RAILROAD COMMISSION OF TEXAS

RE: Sandow Mine, Permit No. 1F
Response to Conditional Approval of Revision Nos. 29, 30 and 31

**Re: Sandow Permit 1F
Revision No. 29, 30 and 31
Response to Comments
File Reference Nos. 1205510, 1206901, 1212507**

SUBJECT: Alcoa Inc. (Alcoa)
Sandow Mine, Permit No. 1F
Revision No. 29 - Incidental Boundary Revision (IBR)
Revision No. 30 - Postmine Land Use Plan Revision
Revision No. 31 - Bond Map Revision ✓

145-B1

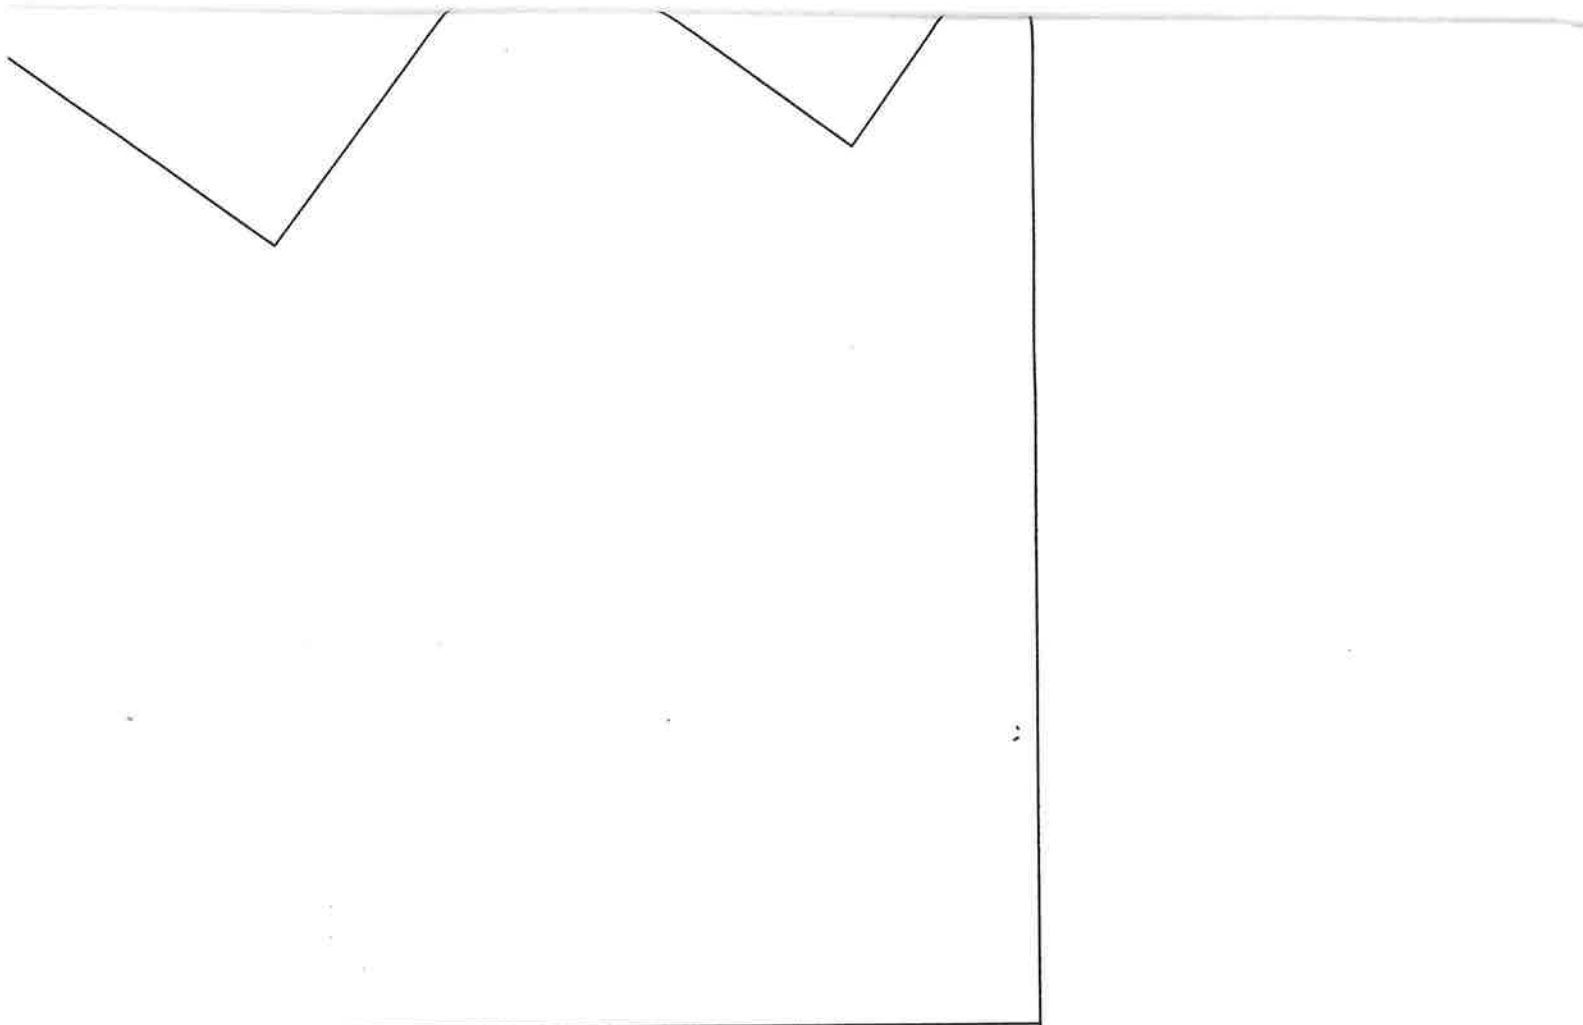
- Within 30 days of this letter, revised bond maps (Dwg. Nos. 145-B1, *North Area Proposed Bond Map*, and 145-B2, *South Area Proposed Bond Map*) must be provided that clearly distinguish between Phase I (mined rate) and Phase I (disturbed rate) areas. The revised maps should also include hatching that clearly identifies Phase III bond release areas since most are surrounded by bonded areas.

- Within 30 days of this letter, Alcoa should be required to provide revised bond maps (Dwg. Nos. 145-B1, *North Area Proposed Bond Map*, and 145-B2, *South Area Proposed Bond Map*, dated revised May 23, 2012) that clearly distinguish between Phase I (mined area) and Phase I (disturbed area) areas. The revised maps should also include hatching that clearly identifies Phase III bond release areas.

Alcoa provided revised bond maps Drawing Nos. 145-B1, *North Area Proposed Bond Map*, and 145-B2, *South Area Proposed Bond Map*, dated July 23, 2012. The bond maps clearly distinguish between Phase I (mined rate) and Phase I (disturbed rate) areas. Although still difficult to easily discern, the Phase III release areas are identified with grey solid hatch. The revised bond maps (dated July 23, 2012) adequately address the conditional approval of Revision No. 29 through 31 and are acknowledged.

Alcoa Inc., Sandow Mine received your letter dated July 24, 2012 regarding Alcoa's Revisions 29, 30 and 31. You requested that Alcoa provide revised bond maps that clearly show the difference between Phase 1 Mined Rate and Phase 1 Disturbed Rate bonding, along with areas that have received Phase III release. Three copies (3) of Drawing Numbers 145-B1 and 145-B2 are provided with this letter.

DWG. NO. 145-B3

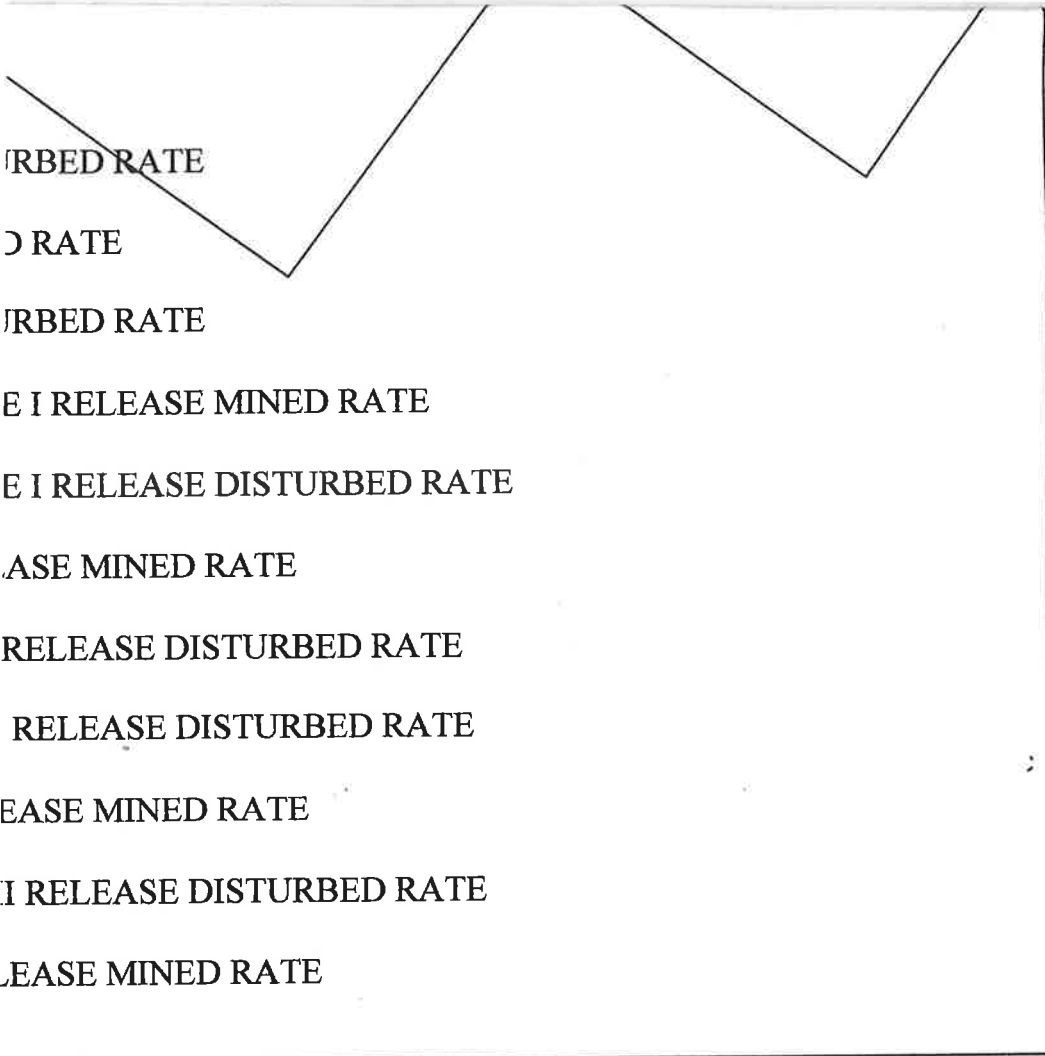
15. The bond change maps, Drawing Nos. 145-B3 and 145-B4, included in this application show the proposed bond category change areas. Alcoa requests an addition of approximately 463 acres of undisturbed area to the disturbed rate category. This 463-acre area was previously inadvertently removed from the approved bond maps and reclamation cost estimate. This error is corrected and the area is shown on the bond maps as being bonded at the disturbed rate. The revised bonded areas are accounted for in Alcoa's revised reclamation cost estimate. Staff notes that the bonding categories shown on the revised bond maps are difficult to distinguish in some areas. Specifically, it would be helpful if the Phase I bond release areas were shown in a manner that allows Staff to identify whether the areas were originally bonded at the mined or disturbed rate. Additionally, several small Phase III bond release areas are identified by a light gray hatch pattern. These areas are also difficult to see in some places because of a lack of contrast with surrounding areas.

1. Alcoa indicates that a disturbed portion of the H-Area was inadvertently considered as undisturbed and removed from the approved bond maps. Comparison of the approved bond maps (Revision No. 17, approved administratively by letter dated August 22, 2011) and the proposed revised bond maps (Drawing Nos. 145-B3 and B4) revealed several areas, in addition to the correction in the H-Area, that are either being added or removed from the bonded area. These areas are described in the following table:

Alcoa must provide a bond change map to facilitate field verification of the proposed changes.

Alcoa Inc, Sandow Mine received your letter dated may 25, 2012 regarding our submittal of revised bond maps for the Sandow Mine. Alcoa has reviewed the areas noted in your letter and made appropriate revisions to correct mapping errors that were found during this review process. Alcoa provides with this response, revised Drawings 145-B3 and B4 that show the bond change categories as requested. These maps show all areas proposed to change from the approved bond map, including those granted various phases of bond release granted since the approval of Revision 17, as well as those areas that have modifications to the bonding rates or categories. Also provided with this response are two drawings, noted as 145-B1 and 145-B2, which show the same bonding information without noting the changes referenced above. These maps show only the appropriate bonding level for each category (mined or disturbed) and the various phases of bond release previously approved by the Commission. Alcoa has also updated the estimated bond calculation based on the changes that occurred as a result of this review, with an estimated bond amount of \$45,818,746 required to cover the final reclamation activities of Sandow, inclusive of the 10% administrative fee. Alcoa does not request a revision to the approved bond instrument of \$56,000,000 at this time. All drawings referenced in this response are provided in electronic format as well as the bond calculations. Should you have any additional questions, please do not hesitate to contact me.
